主旨: s16 Application No. A/YL-KTN/1264 : 補充文件
附件: A_YL-KTN_1264_Approved Drainage Proposal..pdf; A_YL-KTN_1264_Approved FS_Plan.pdf

Proposed Temporary Private Club for a Period of 3 Years at Lot 130 RP in D.D.110 and Adjoining Government Land , Kam Tin, Yuen Long

TEMPORARY DRAINAGE PROPOSAL

Application Site of Proposed Temporary Private Club for a
Period of 3 Years in Lot 130 Rp in D.D.110 and Adjoining
Government Land, Kam Tin, Yuen Long, New Territories
Issue 3 (November 2024)

PROPOSED DRAINAGE WORKS

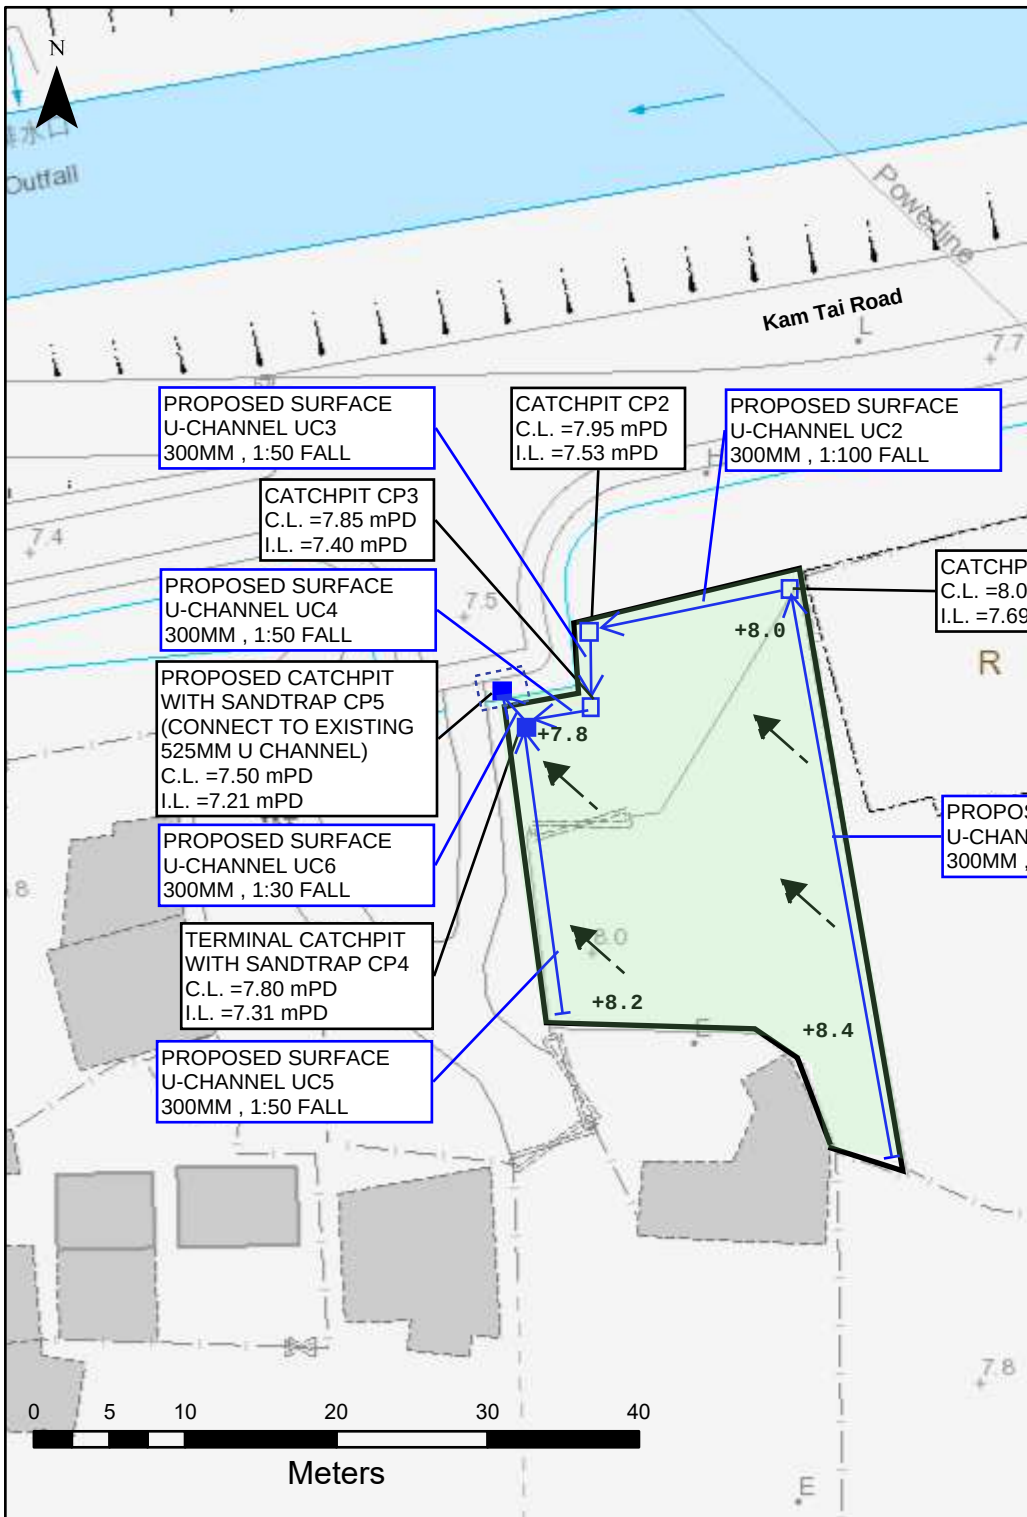
No.	Comments	Response
1	A surface channel at the peripheral of the site should be constructed to intercept all such rainwater falling onto the site.	Noted. Surface channels are proposed on three sides of the site. The remaining side is at the high point of this site and adjacent sites which will not intercept rainfall. Please refer to Appendix D.
2	Section 3: Please clarify why North District Area is adopted.	The rainfall statistics is revised to HKO Headquarters.
3	SDM Corrigendum Nos. 1/2022 and 1/2024 should be considered.	Noted with thanks.
4	The cover and invert levels of the proposed u-channels and catchpits should be shown on the drainage plan.	Noted. Appendix D1 is updated.
5	Please indicate the runoff (the flow direction) of the adjacent areas to show if there are any external catchment areas to be considered.	Noted. Appendix D2 is updated. It is noted that 510m ² of adjacent catchment area may fall on the application site. For conservative approach, a total of 1120 m ² (610 m ² + 510 m ²) area are considered in the design calculation. 300mm surface channels are found adequate to capture the external surface runoff.

Appendix D3 Cross Section of Site and Adjacent Areas

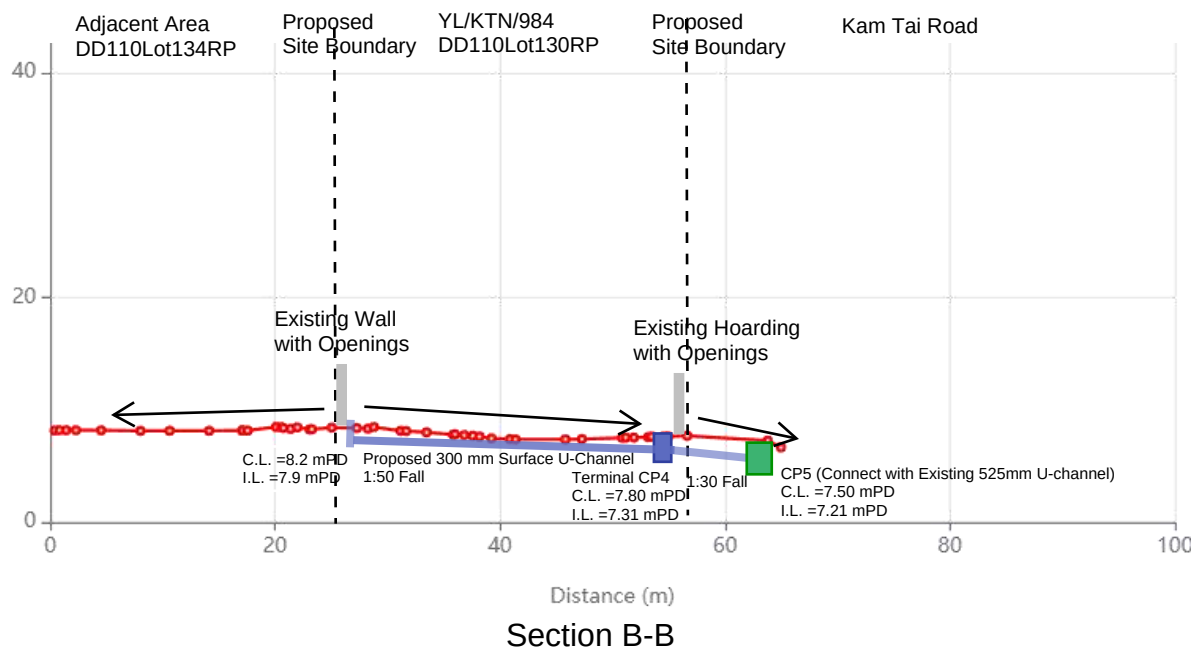
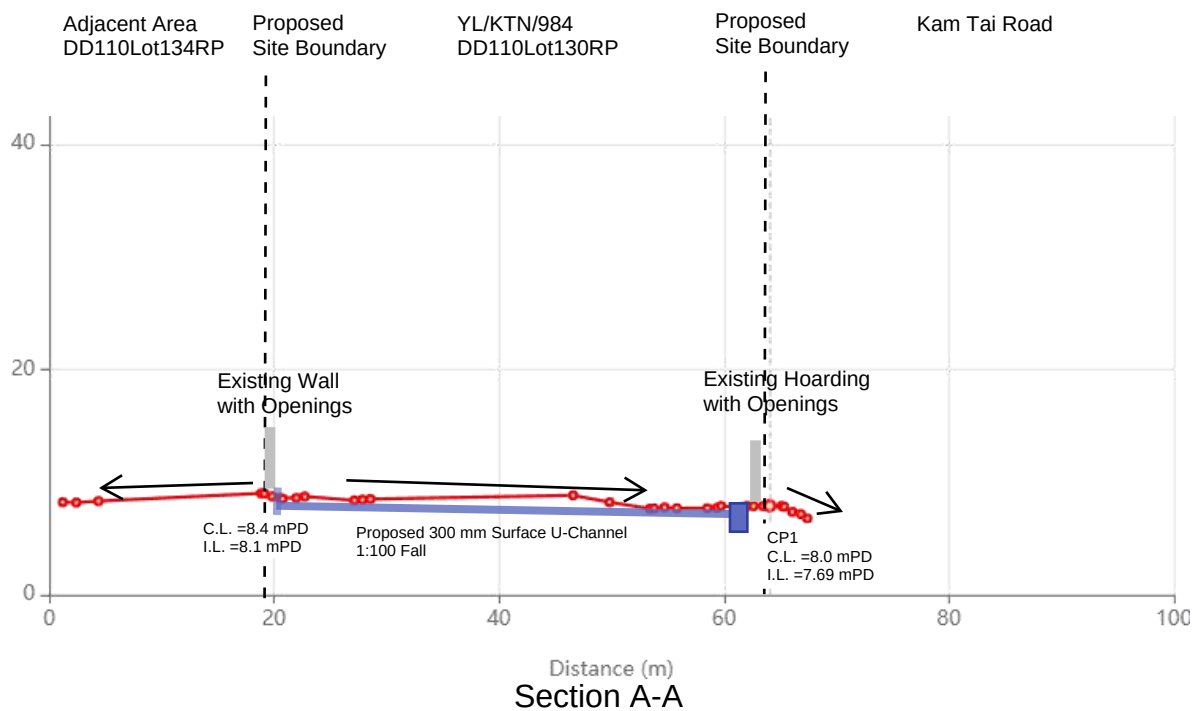
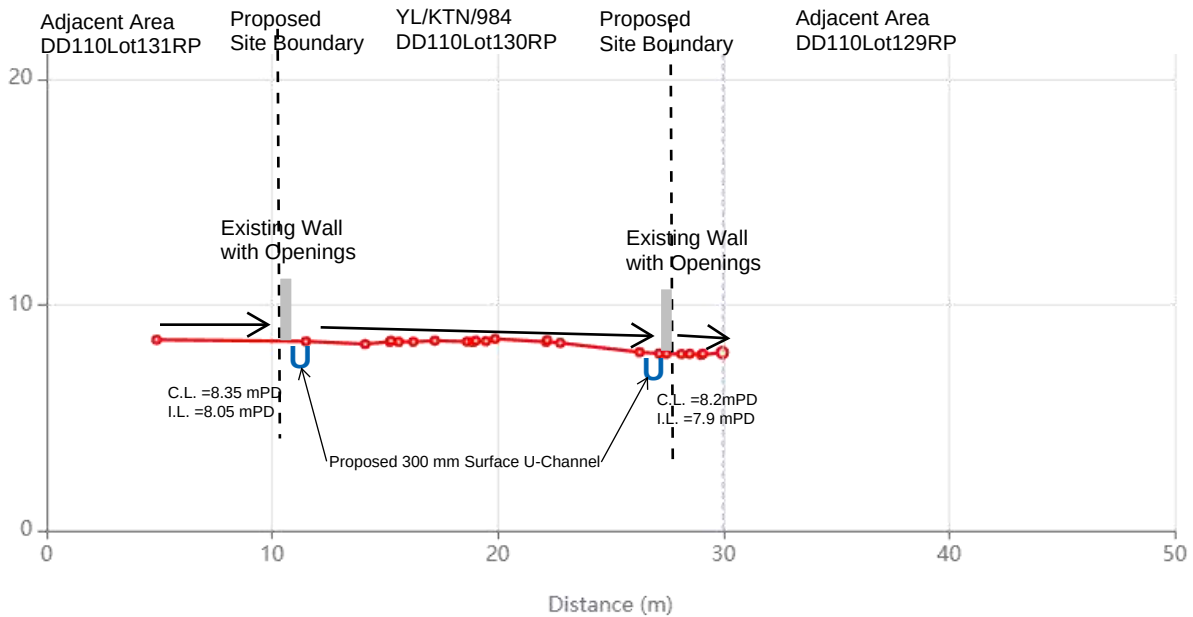
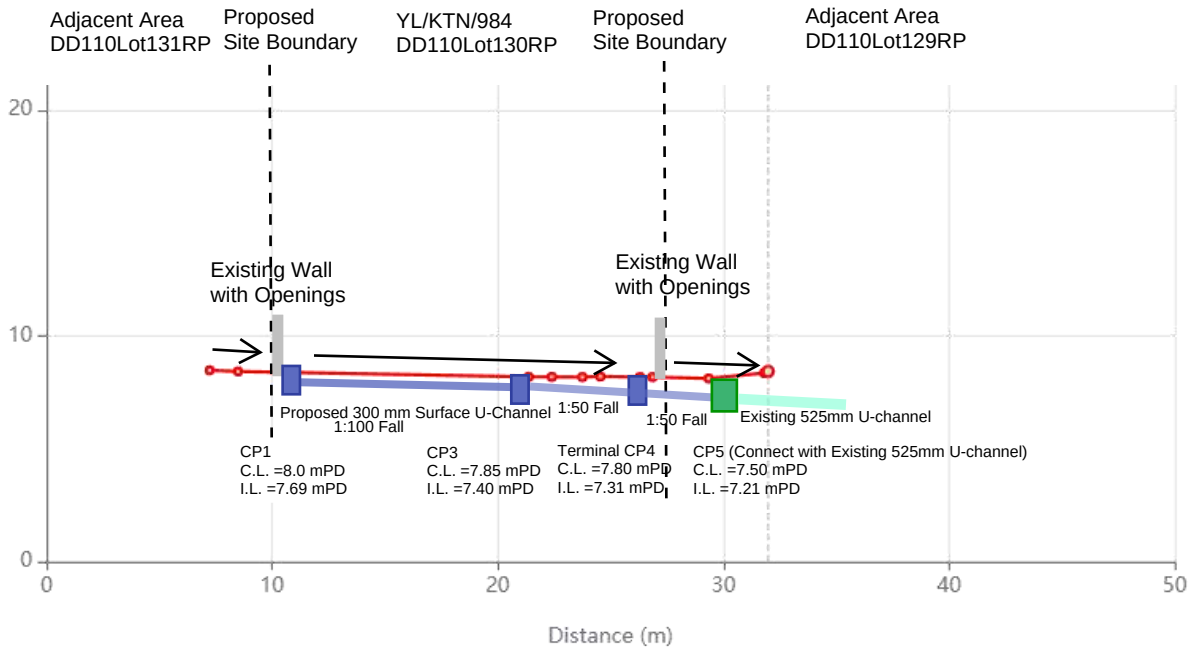
6	Please clarify whether any walls or hoarding would be erected along the site boundary. Where walls or hoarding are erected/laid along the site boundary, adequate opening (practically 100mm all along the wall) should be provided to intercept the existing overland flow passing through the site.	Please be clarified that hoarding and walls with adequate opening will be erected along the site boundary. Please refer to Appendix B with updated photos attached.
7	More cross sections in different directions showing the existing and proposed ground levels of the captioned site with respect to the adjacent areas should be given. Adjacent ground levels should also be shown in Section A-A.	Noted. Section B-B, C-C and D-D are added in Appendix D3.
